Service Bulletin : X Series Motor
Mount Weld

Reference: SBV 11.08

Date of Issue: 19th October 2011**Affected Machines: Snorkel / Upright X26N, X26, X32****Serial Numbers:**
X26N 51172 to 51200
X26 53251
X32 53250**MANDATORY MACHINE INSPECTION AND WELD REPAIR TO BE CARRIED OUT
IMMEDIATELY**

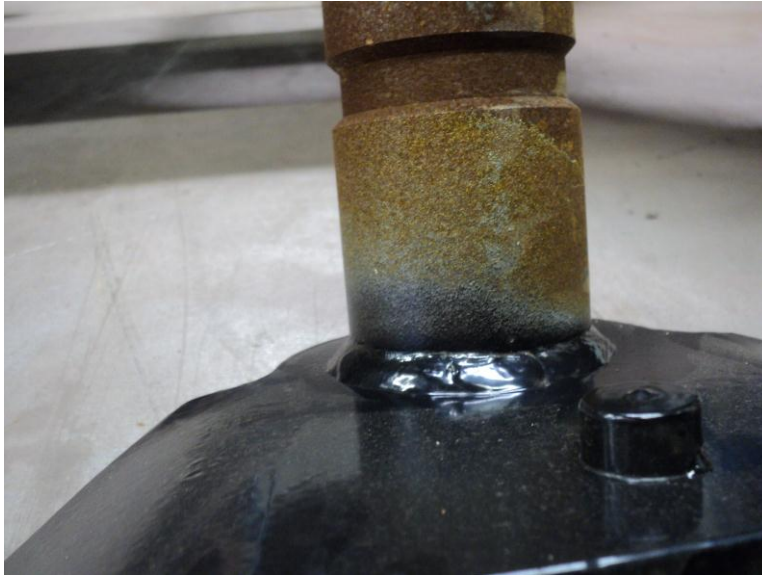
A quantity of left and right hand drive wheel motor mounting fabrications have been manufactured by our supplier with a structural weld fillet missing. The main steering spindle (Kingpin) must be welded to the top of the motor mount plate and this weld fillet has been omitted as shown below.

Action: It is mandatory that the X Series machines identified in the serial range above must be inspected upon receipt of this bulletin to confirm whether the weld fillet indicated is missing.

If this is the case then the machines must be removed from service immediately and not returned to service until a weld repair has been carried out.

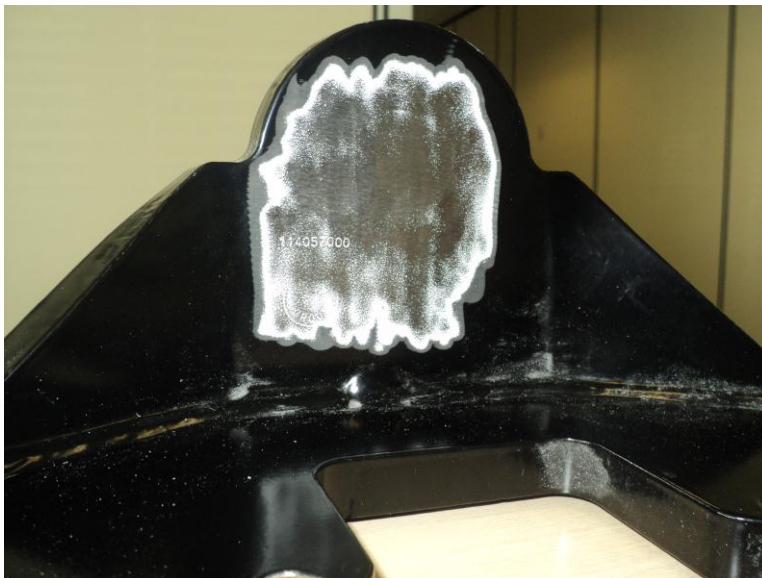
7. The weld repair should only be carried out by a competent certified weld operator
8. Using either MIG or MMA stick weld equipment apply a continuous hot root weld bead around the steering pivot to motor mount plate interface. The weld bead should be a consistent (6 mm) thick bead all the way around the steering pivot, capping off with a 6mm fillet weld, as shown below
